NOTES ON THESE PLANS HAVE BEEN MADE TO MOVE ALL DOORS TO THE SAME SIDE TO ALLOW FOR EASE OF MAINTENANCE. ARCHITECT HAS REVIEWED THE PROPOSAL AND HAS AFFIRMED THE BUILDING WILL STILL BE STRUCTURALLY SOUND. SEE ATTACHED EMAIL ATTACHED TO THE END OF THIS PLAN SET.

BLACKSMITH FORK PARK  
RESTROOM  
HYRUM, UT  
HYRUM CITY PARKS & RECREATION

RESTROOM PLAN  
ELEVATIONS AND  
CEILING

A4 FLOOR PLAN

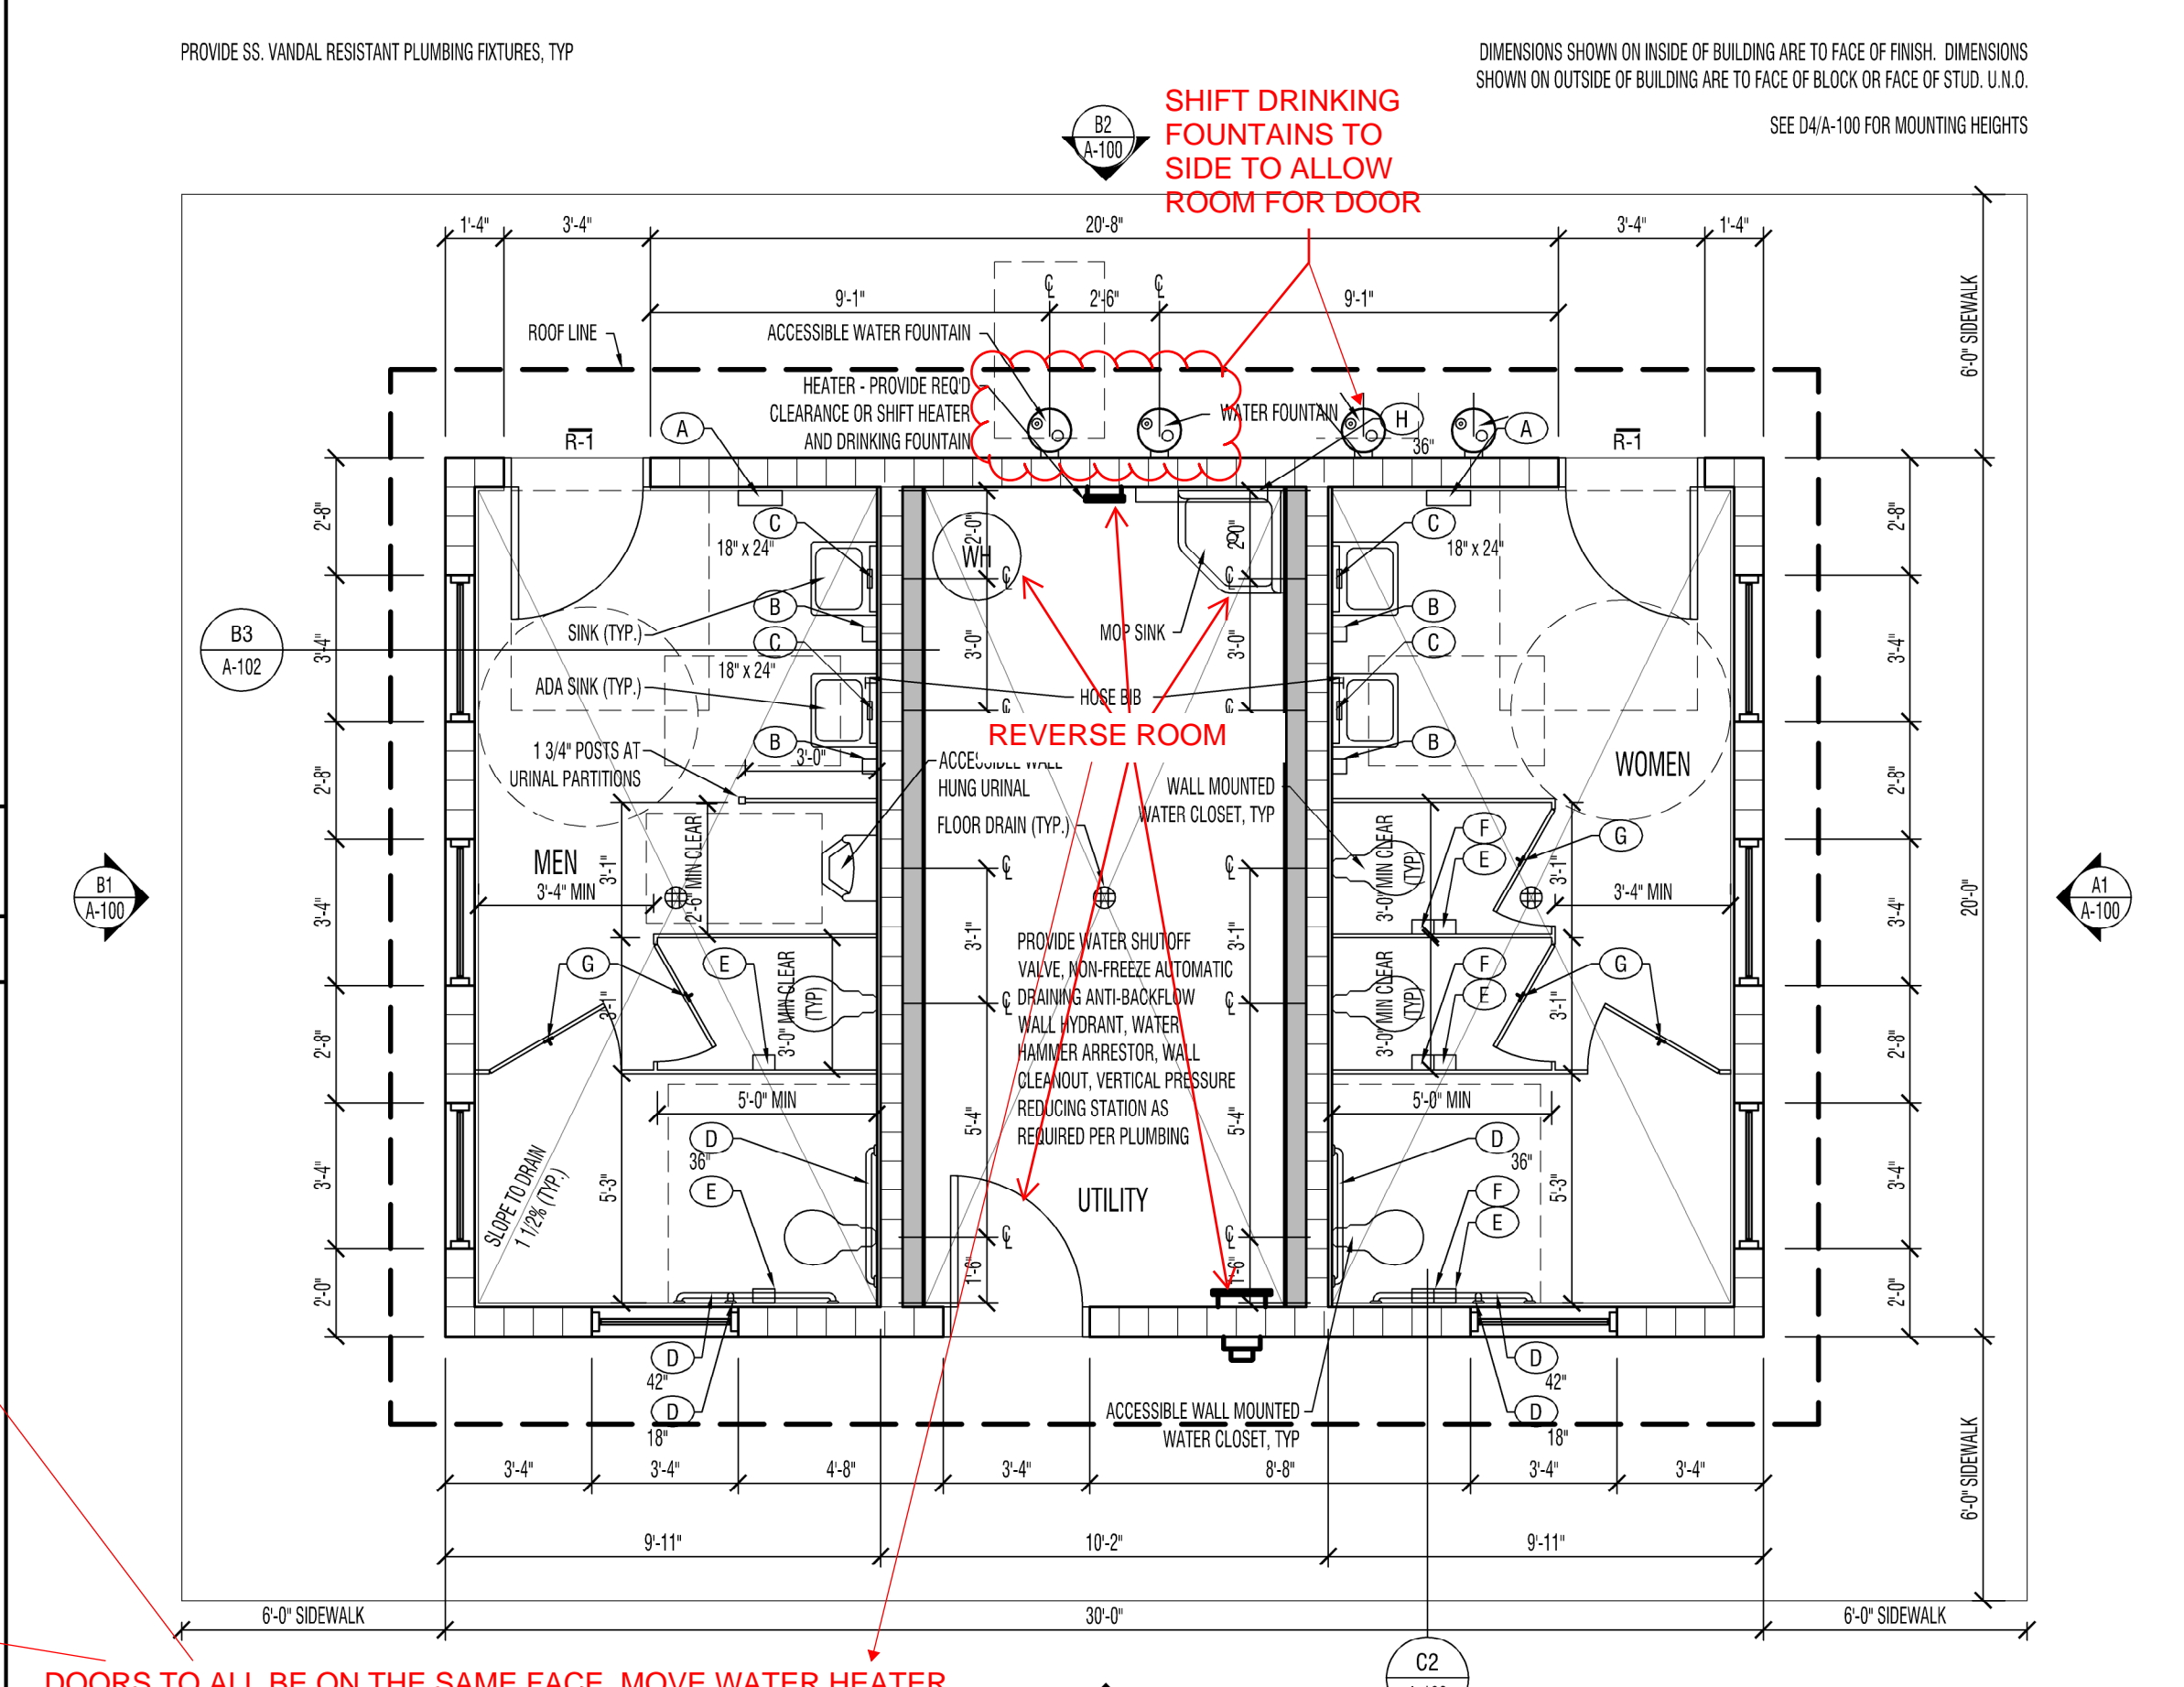
DOORS TO ALL BE ON THE SAME FACE, MOVE WATER HEATER AND MOPSINK AND WALL HEATER TO BOTTOM WALL. DOOR AND ELECTRIC PANEL/METER TO BE MOVED TO TOP WALL.

**ROOF FRAMING PLAN**  
SCALE: 3/8" = 1'-0"

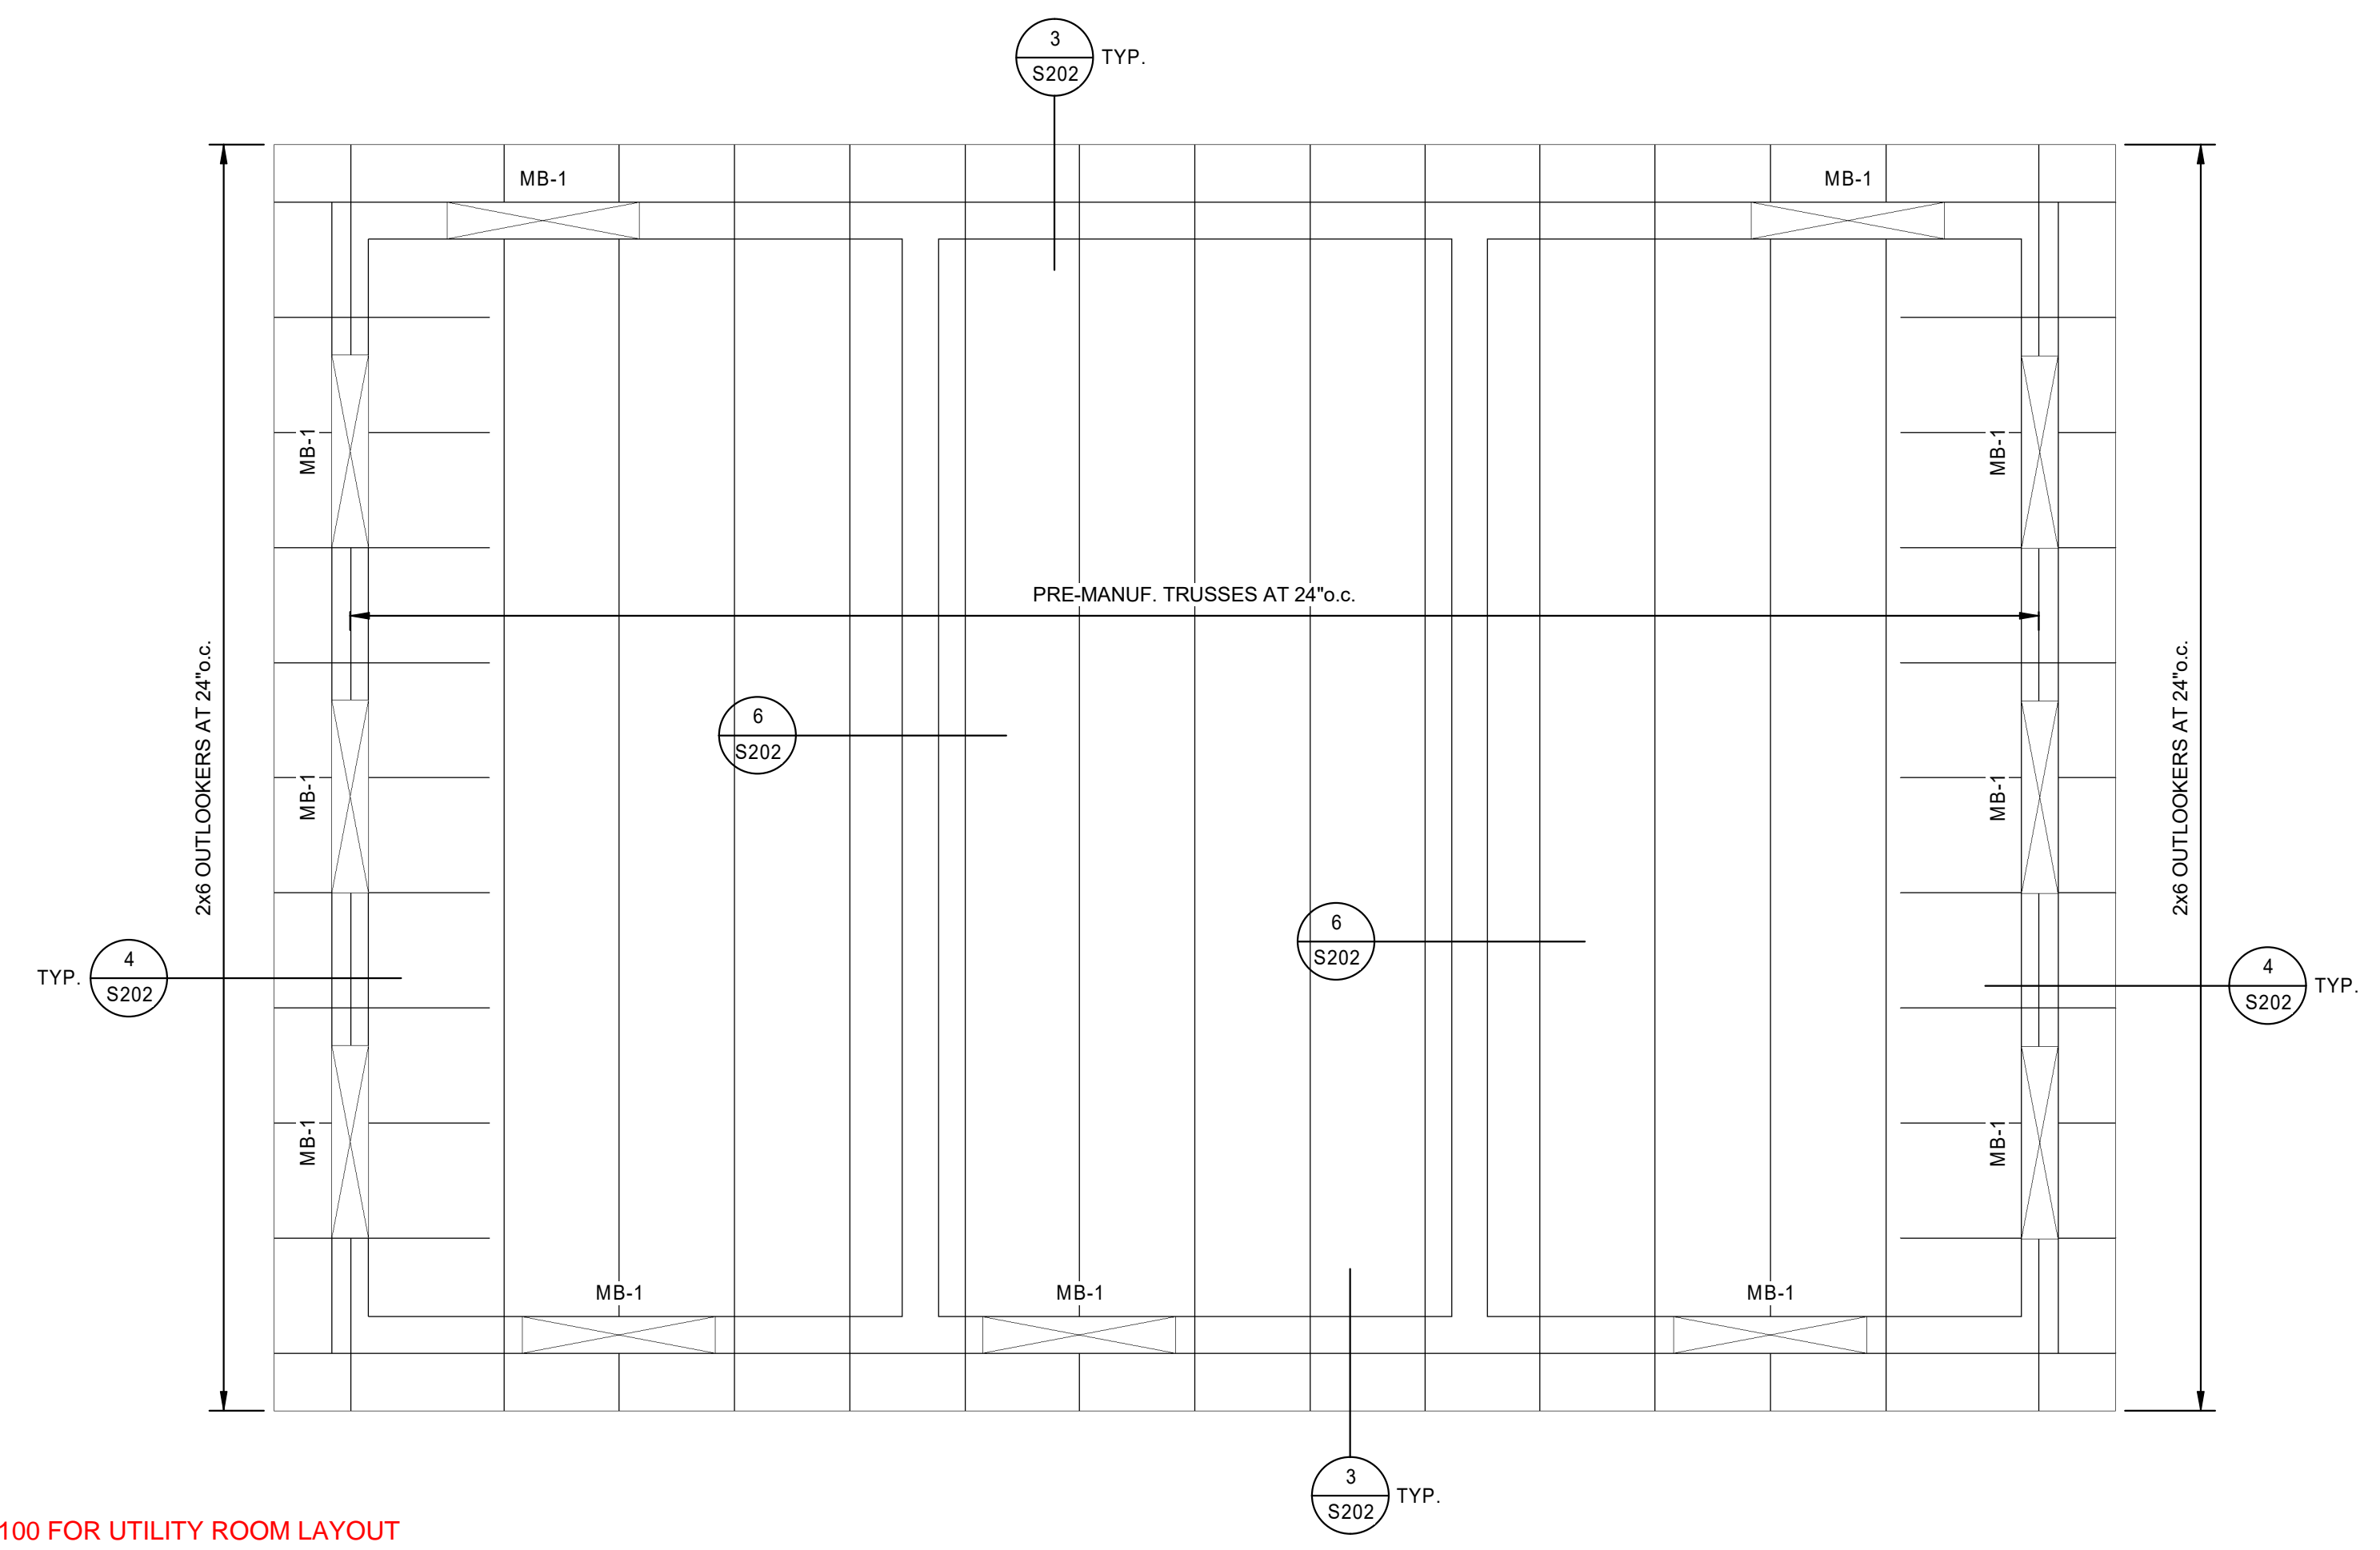
SEE REVISION ON SHEET A-100 FOR UTILITY ROOM LAYOUT

4 ONE-LINE DIAGRAM  
E-201 NO SCALE

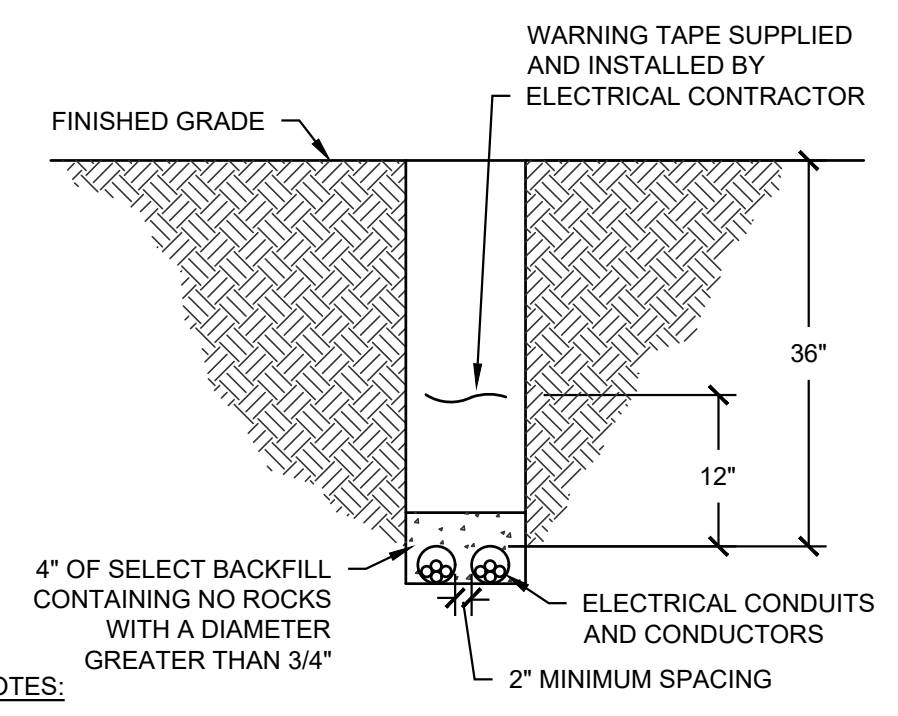
AMPHITHEATER LIGHTS TO BE REPLACED WITH SKATE PARK AND DOG PARK. SOME BREAKERS TO BE AVAILABLE FOR FUTURE BIKE AREA. NO SOFTBALL LIGHTS

1 LIGHTING PLAN  
E-201 SCALE: 1/4" = 1'-0"

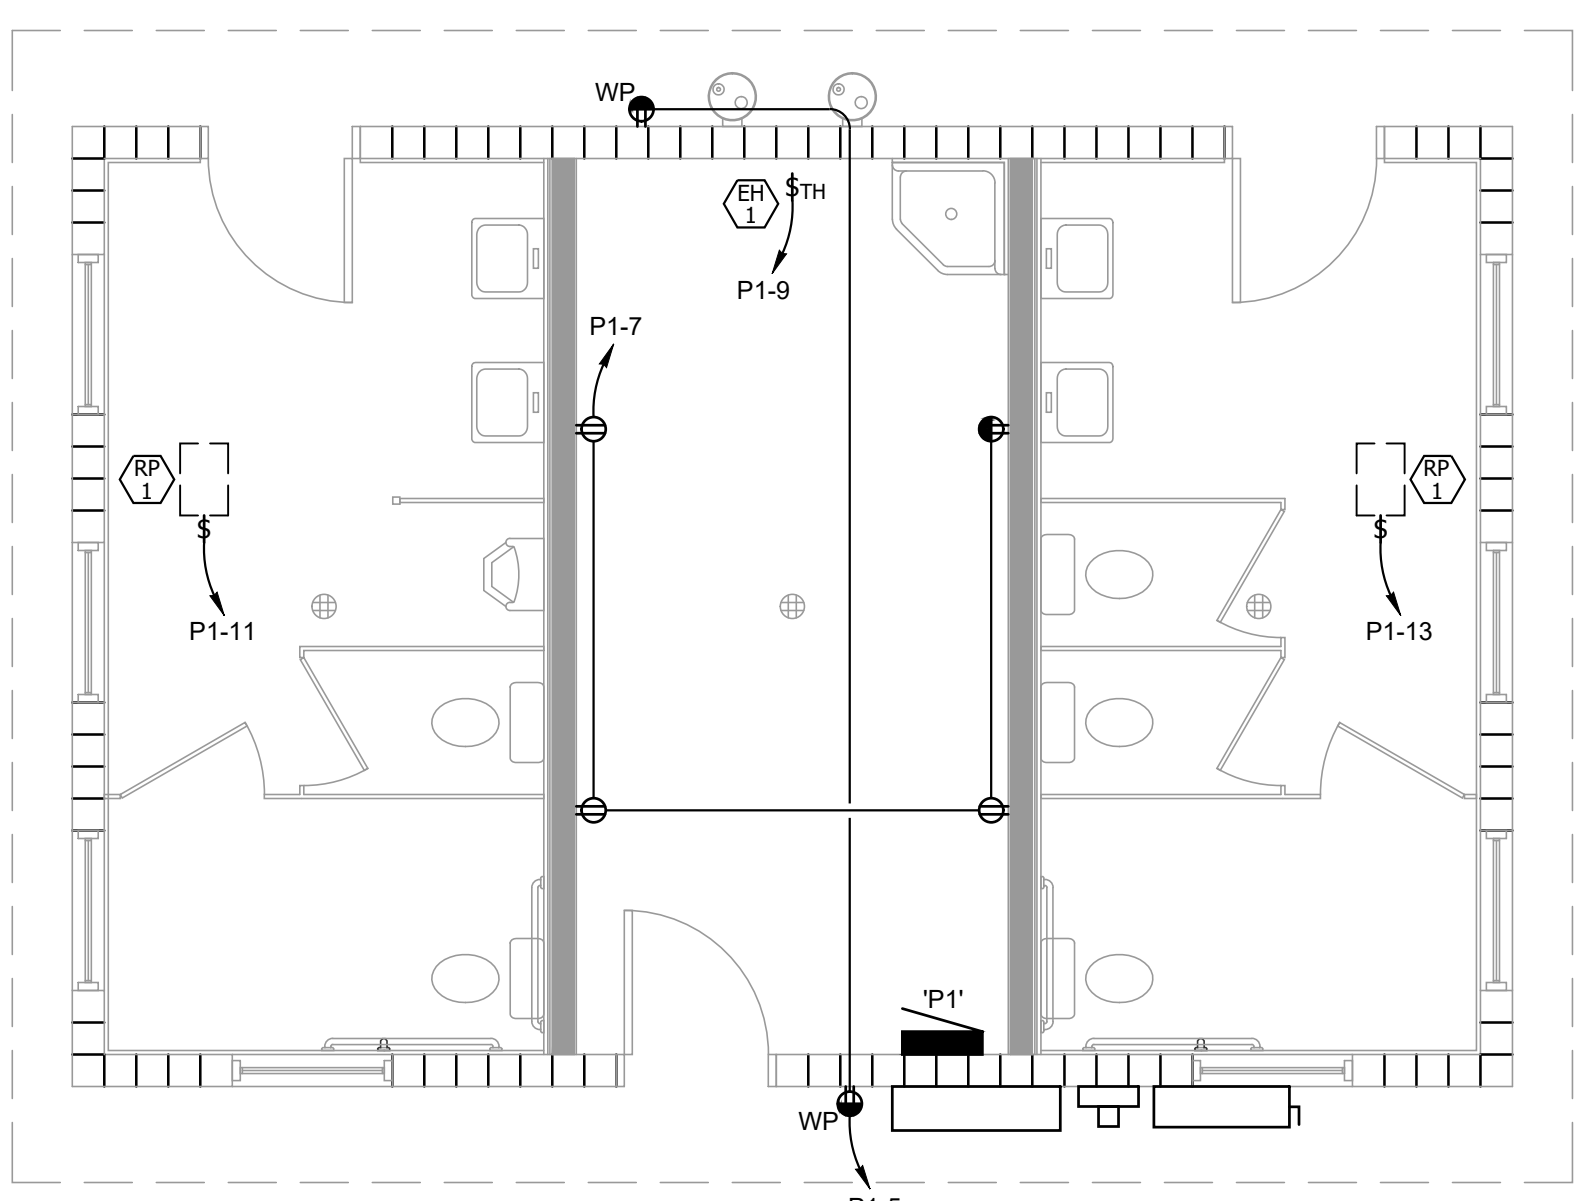
SEE REVISION ON SHEET A-100 FOR UTILITY ROOM LAYOUT
